Access Compliance Report
Public Rights-of-Way
(Curb Ramps)

Intersection ID: 2609 | **Main Street:** ANZACK_LN | **Cross Street:** HARTFIELD_DOWNS_DR | **Location:** SE

ADA ID: 15C7381CD3BF | **Ramp Type:** BlendTrans1 | **Initial Pass/Fail:** Fail | **Overall Compliance:** No | **Severity Score:** 10

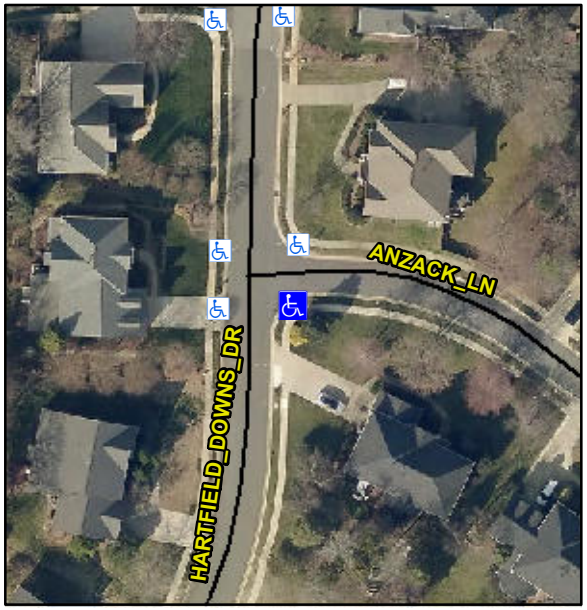
PROW/ADA:

R304.5.1, R304.5.3

Compliance	Description	Data	Compliance	Description	Data
N/A	Ramp Length (in)	47.0	Yes	BlendTrans Slope (%)	2.5
No	Ramp Width (in)	45.5	No	BlendTrans XSlope (%)	3.8
N/A	Flare Type LT	N/A	N/A	Flare Type RT	N/A
N/A	Flare Slope LT (%)	N/A	N/A	Flare Slope RT (%)	N/A
N/A	Flare Traversable LT?	N/A	N/A	Flare Traversable RT?	N/A
N/A	Landing Length (in)	N/A	N/A	DWS Provided?	N/A
N/A	Landing Width (in)	N/A	N/A	DWS Contrast?	N/A
N/A	Landing Slope (%)	N/A	N/A	DWS Length (in)	N/A
N/A	Landing X Slope (%)	N/A	N/A	DWS Full Width?	N/A
N/A	Landing Curb? (Y/N)	N/A	N/A	DWS Offset (in)	N/A
N/A	Shared Landing?	N/A			
N/A	Gutter Ponding?	N/A	N/A	Gutter Slope (%)	N/A
N/A	Gutter Lip Ht (in)	N/A	N/A	Gutter X Slope (%)	N/A
N/A	Painted X Walk1?	No	N/A	Painted X Walk2?	No
	X Walk 1 Direction	To N		X Walk 2 Direction	To W
	X Walk 1 Width (in)	N/A		X Walk 2 Width (in)	N/A
	X Walk 1 Slope (%)	2.6		X Walk 2 Slope (%)	4.2
	X Walk 1 X Slope (%)	3.3		X Walk 2 X Slope (%)	7.4

Remove & Replace Curb Ramp With Two New Directional Ramps or Equivalent.
